Denitex Limited.

9/1, Kornopara, Savar, Dhaka-1340
(23.823528, 90.256569)
22 March, 2016

Client Summary Report

Observations & Actions

High Stress on Column

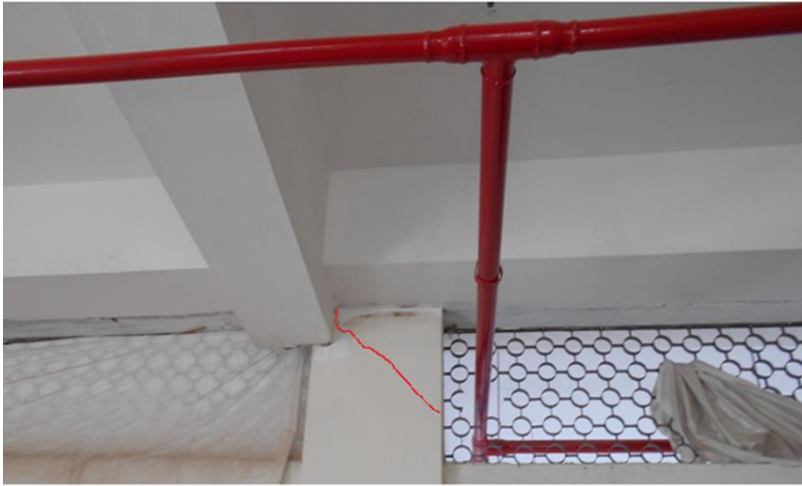
RCC column in cantilever
portion of the building
only in roof for
Architectural Purpose.

RCC columns in roof provided for architectural purposes not continued to the bellow floor hence acting as point load in cantilever portion of the building.

10" high concrete
plinth.

- No additional loads to be applied on area indicated in red on all floors
- Factory Engineer to review design, loads and columns stresses in area identified above.
- Verify insitu concrete stresses by 100mm diameter cores.
- A Detail Engineering Assessment of Factory to be commenced, see attached Scope
- No vertical or horizontal extension before completion of Detail Engineering Assessment.

- Produce and actively manage a loading plan for all floor plates within the factory giving consideration to floor capacity and column capacity.
- Building engineer to investigate the crack of the column.
- Detail Engineering Assessment to be completed

High stress on column

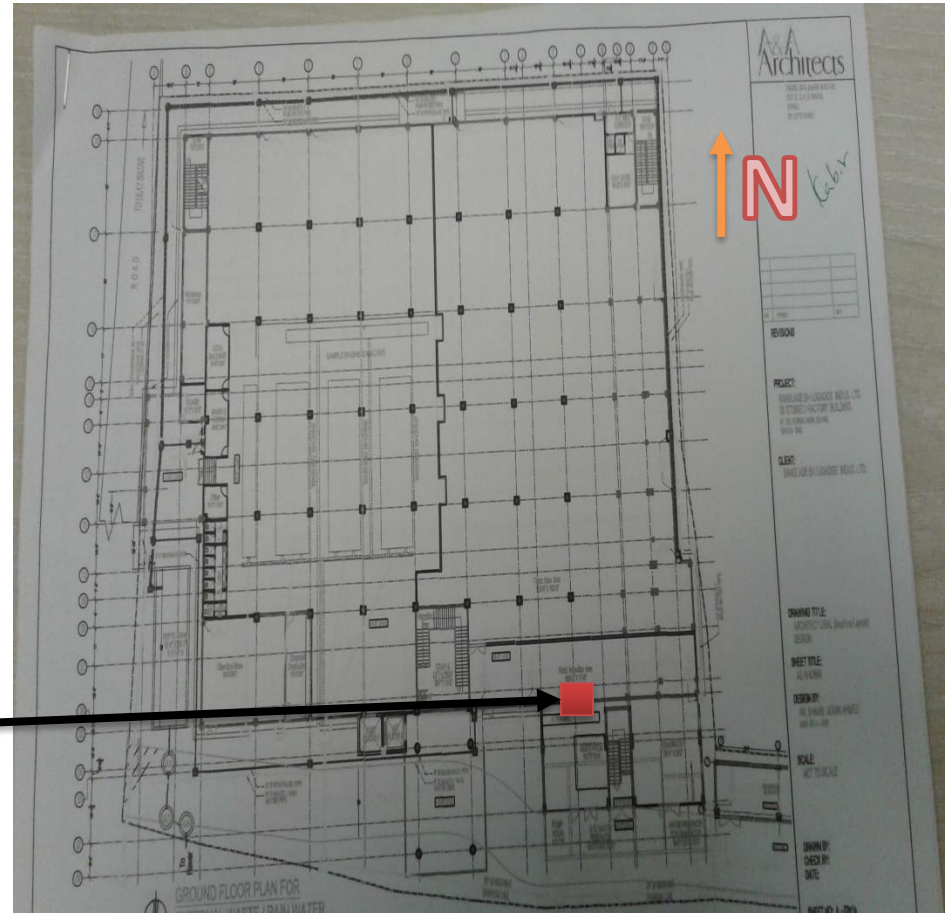
9 (5000 L) water tank upon 10" built up

RCC columns only in roof
for architectural purpose

High stress on column

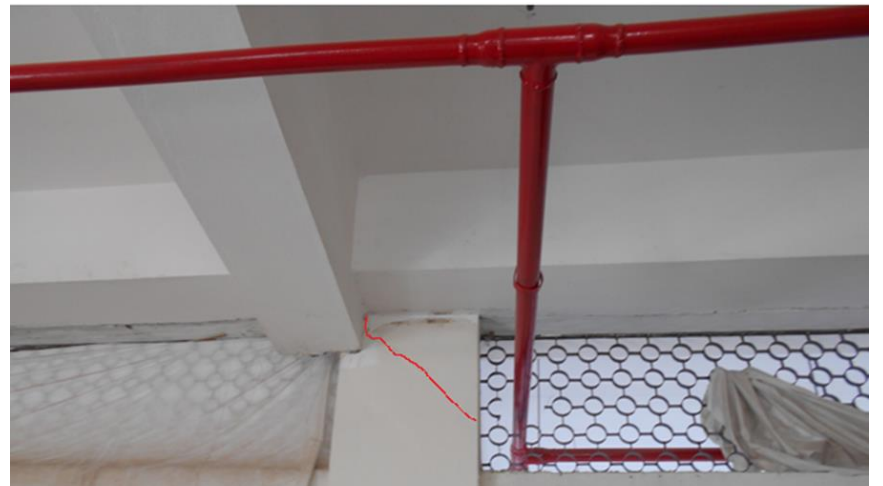
Column with eccentric beam found cracked
Unclear Beam-Column arrangement.

After plaster removal, significant crack depth found.

Discontinued, offset, eccentric & Deflected beam.

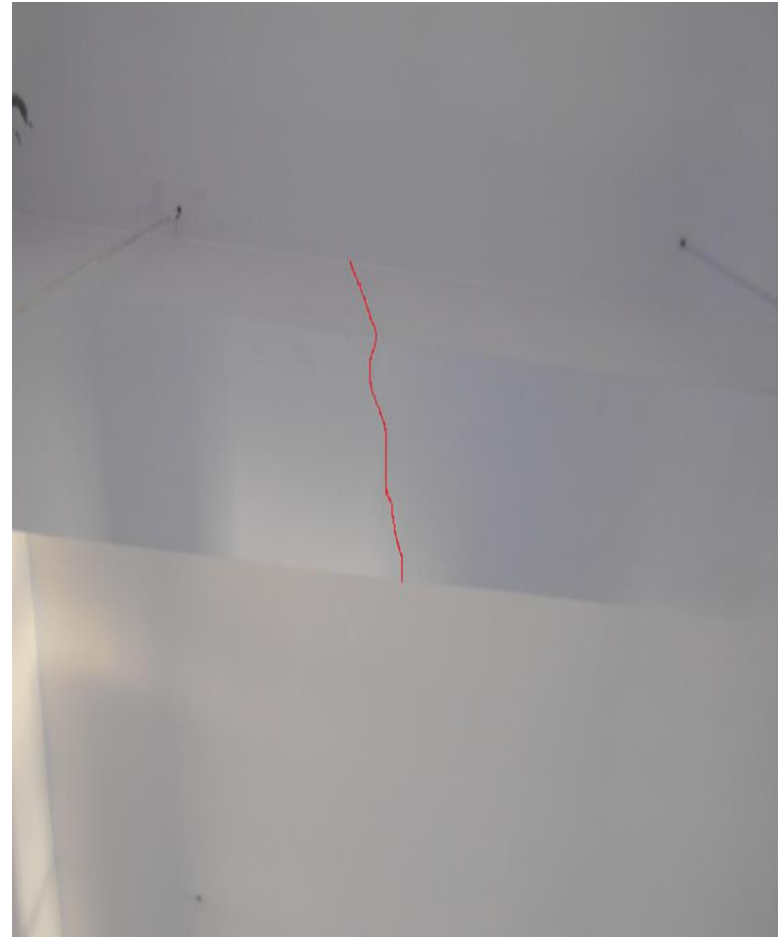
Beam offset to the column at 4th Floor

Discontinued beam in every floor on several grid

Eccentric beam in 5th floor

- Building engineer to review the design of beams of the building.
- Building engineer to investigate the cracks of the beam & suggest remedial action.

- Perform strengthening work to the deflected beams if deemed necessary by the DEA.

Discontinued, Deflected, Offset and Eccentric beam.

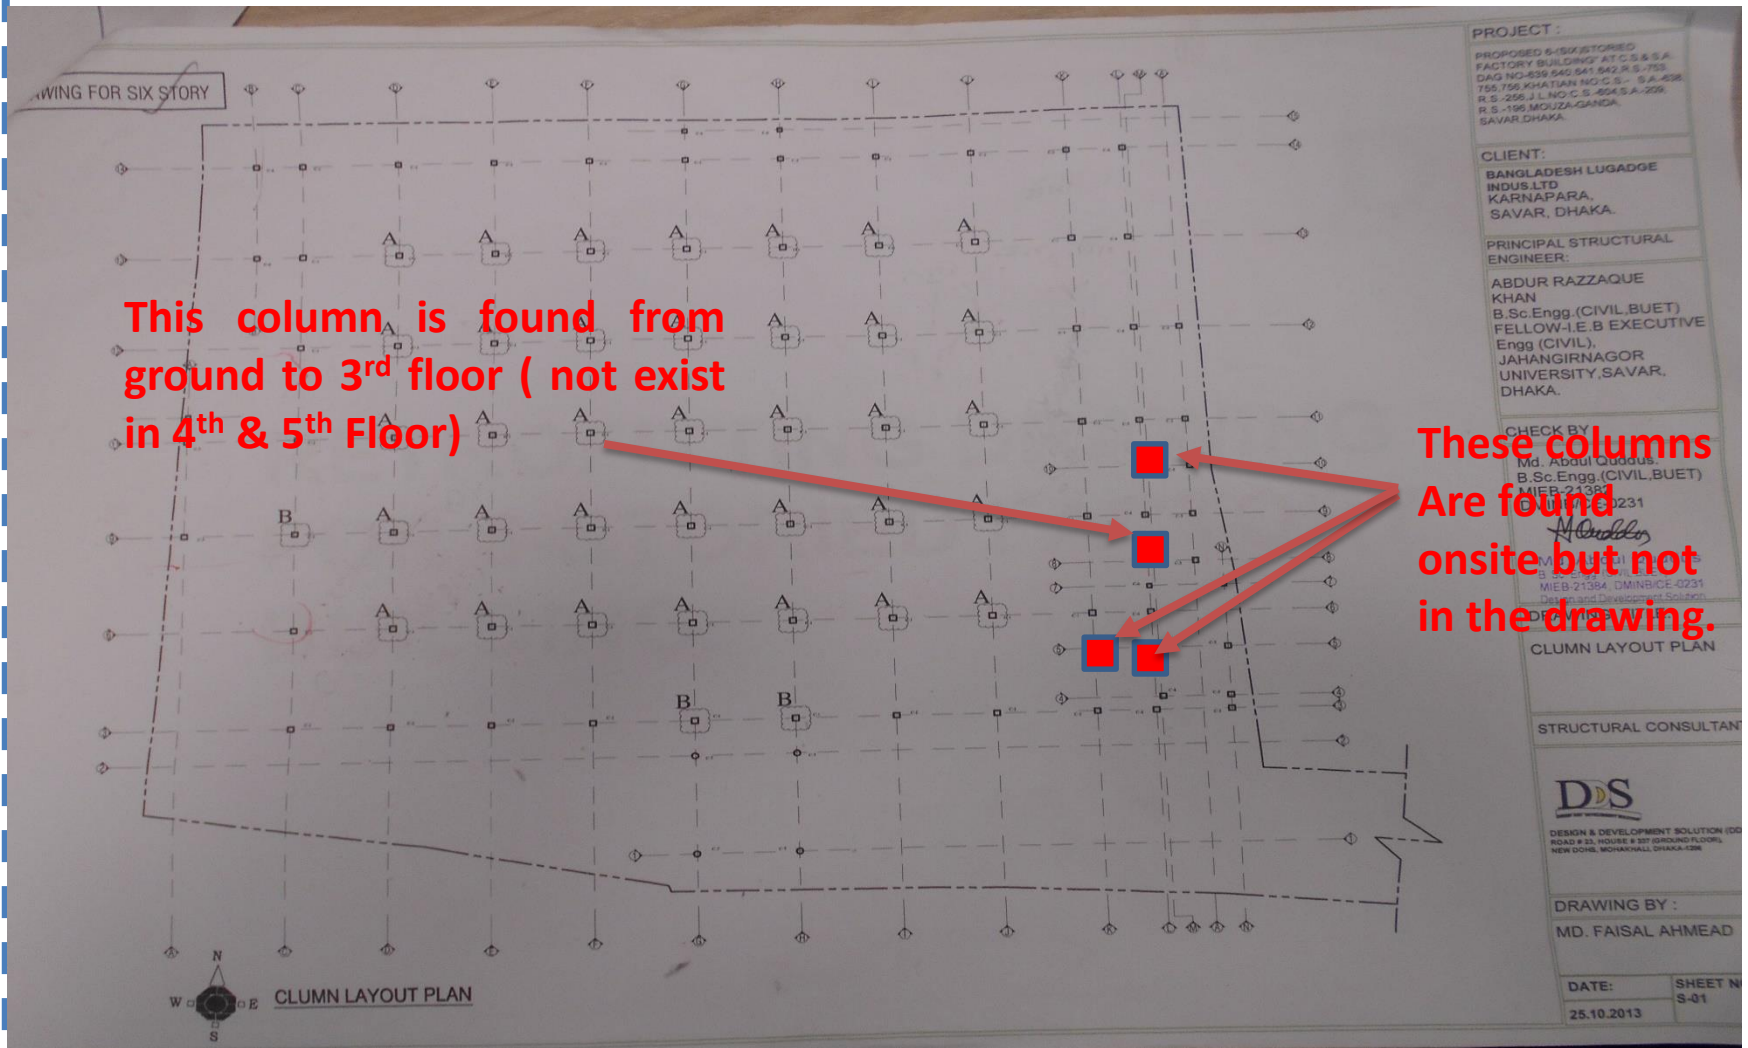
Deflected beam with crack observed in 5th Floor of the building.

Discontinued beam and Eccentric beam.

SHEET NO.
S-23

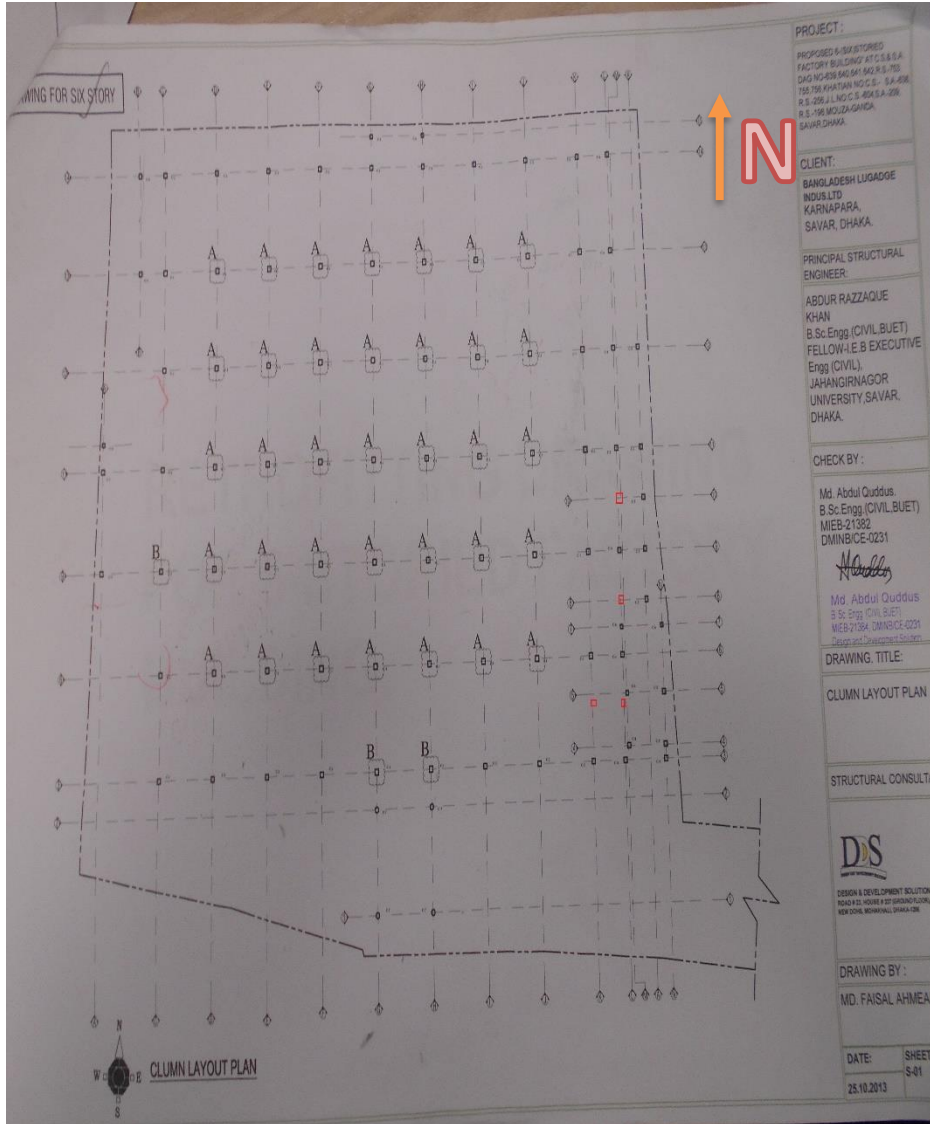
Inconsistencies of drawings and As built construction.

Inconsistencies of drawings and As built construction.

- Review actual existing site conditions and update structural and permit drawings as required

Inconsistencies of drawings and As built construction.

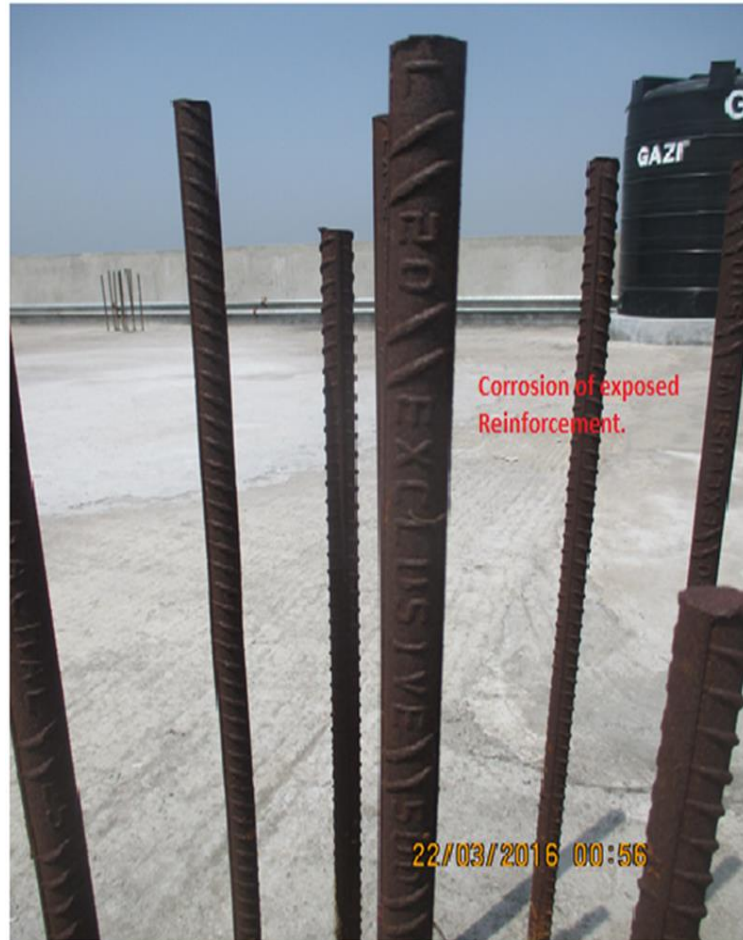
C5, C6 & C7 column is not shown in column schedule but found in column layout of structural drawing.

**No water proofing membrane appears on roof &
Exposed reinforcement of column.**

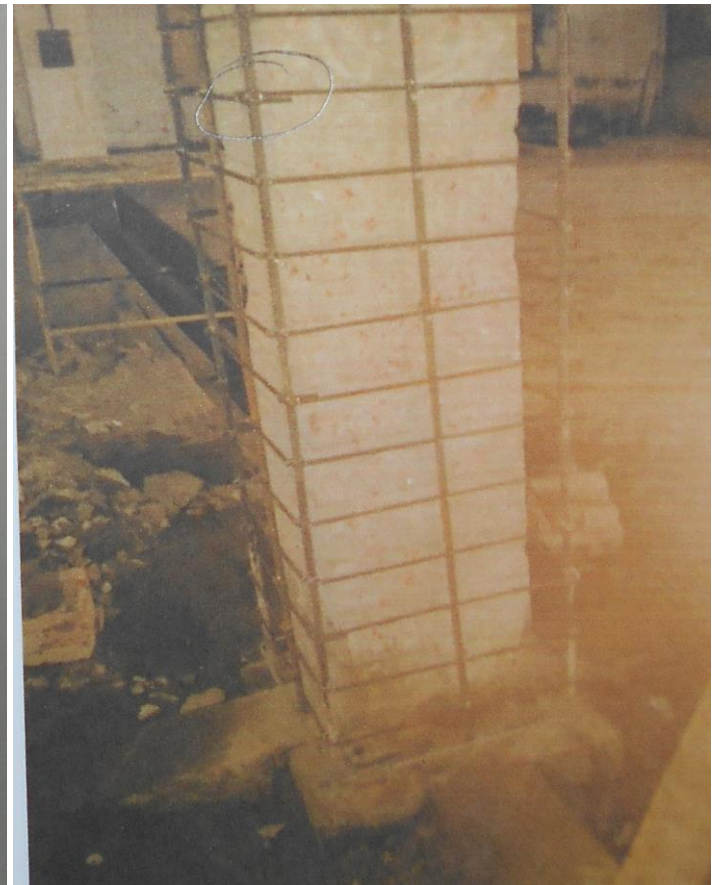
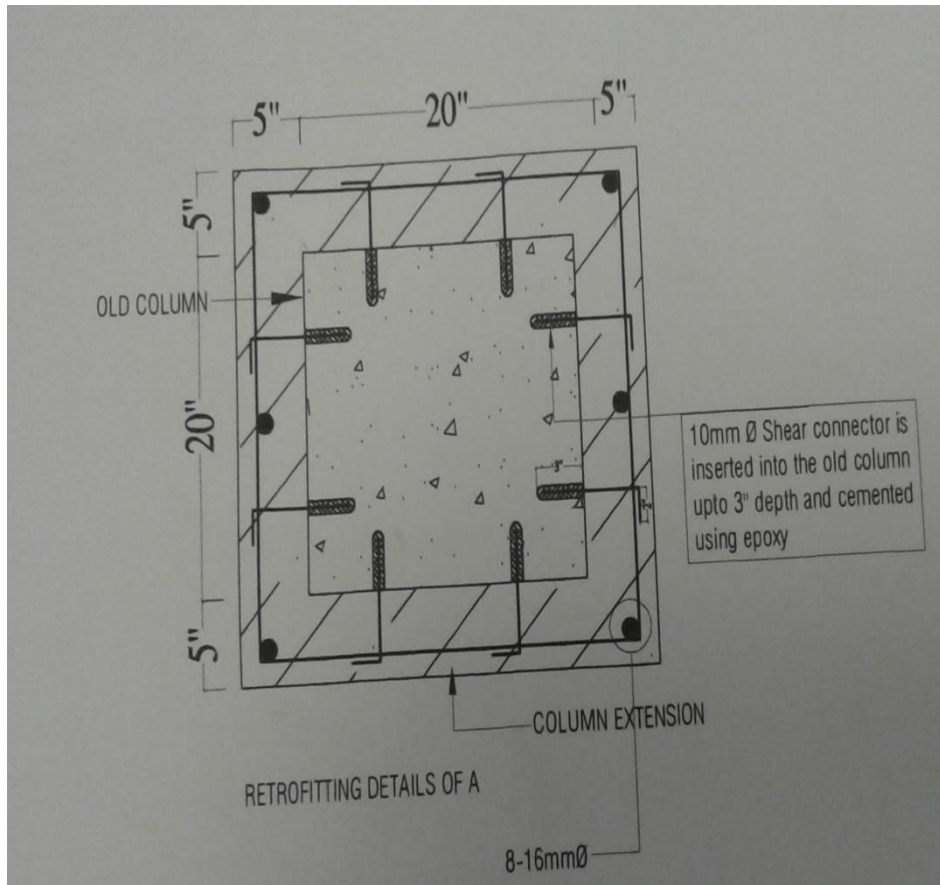
There did not appear to be any waterproofing to the concrete roof. The concrete of the roof will be subject to large temperature changes as it heats up in the sun and cools. This will induce stresses in the structure and could lead to cracking of the concrete slab. In the long term the cracking and lack of waterproofing could cause leaks and durability issues for the structure.

No water proofing membrane appears on roof.

Corrosion in exposed reinforcement. Steel reinforcement projects from roof slab.

- Protect projecting bars by casting a concrete 'cap' over area of column.
- Fix water tank overflow so that it doesn't discharge on to column below.

- Investigate options to ensure that the structure is not subject to deterioration arising from possible thermal cracking in concrete roof and consequent water penetration.
- Consideration should be given to waterproofing the roof.

Building 2

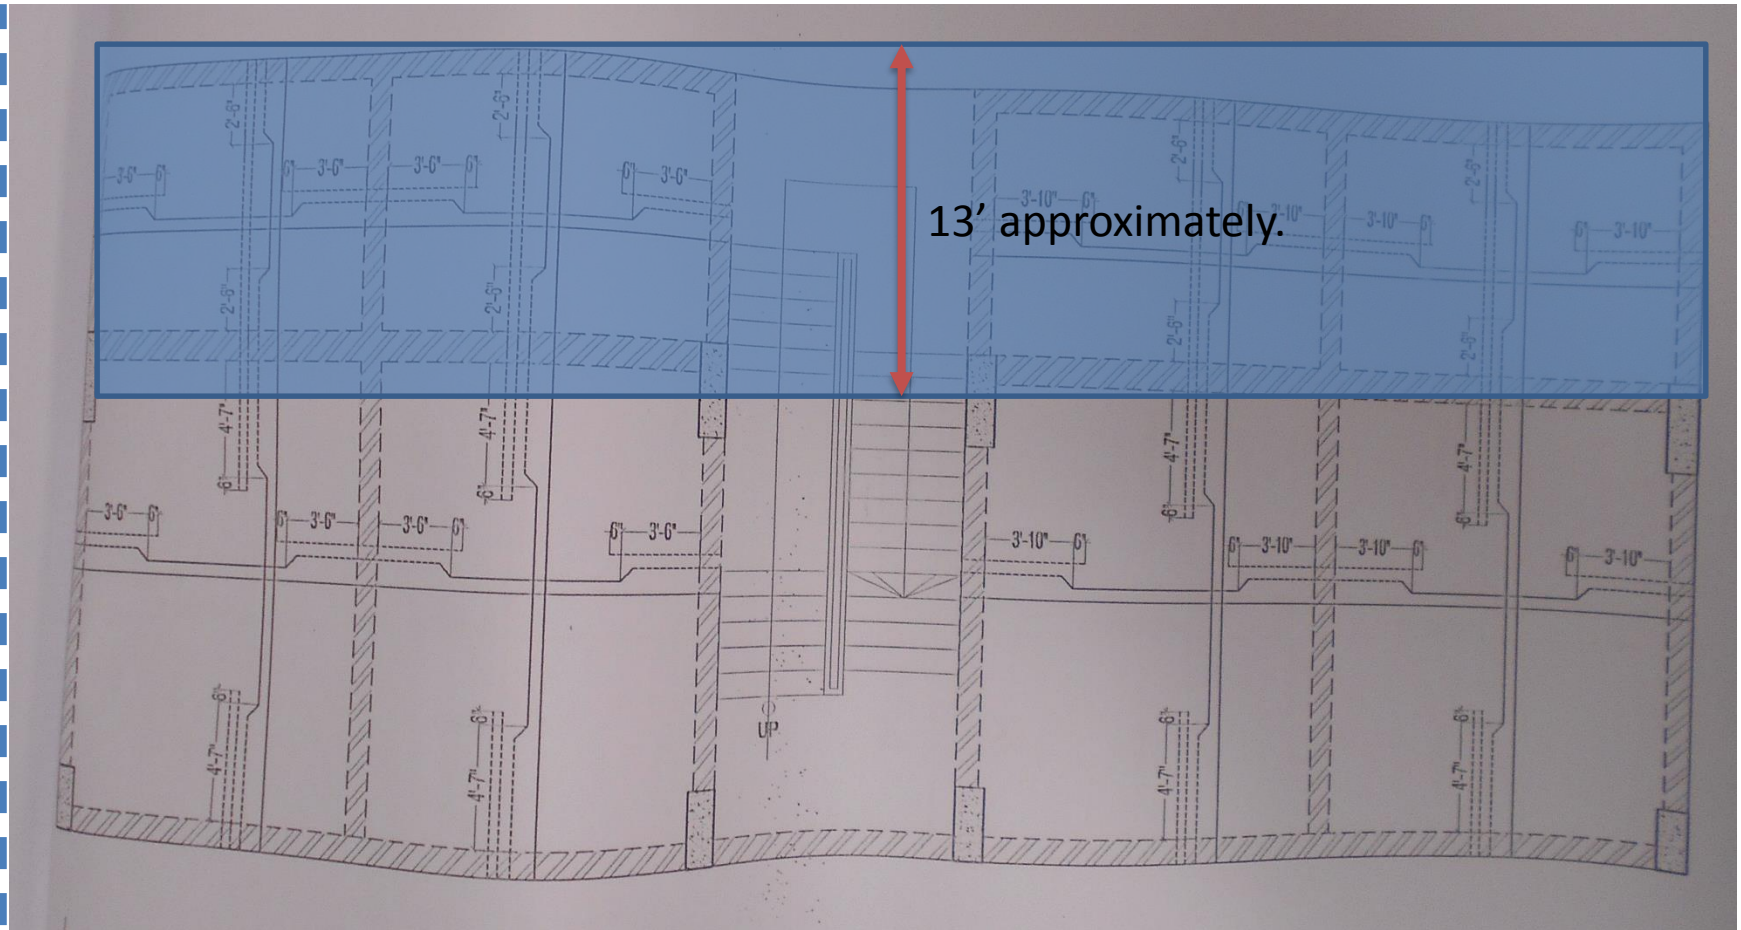
Large cantilever portion of the building

Large beam-cantilever portion with of approximately 13' .

- Building engineer to find the actual slab thickness & carry out a design adequacy check for the cantilever portion of the slab.
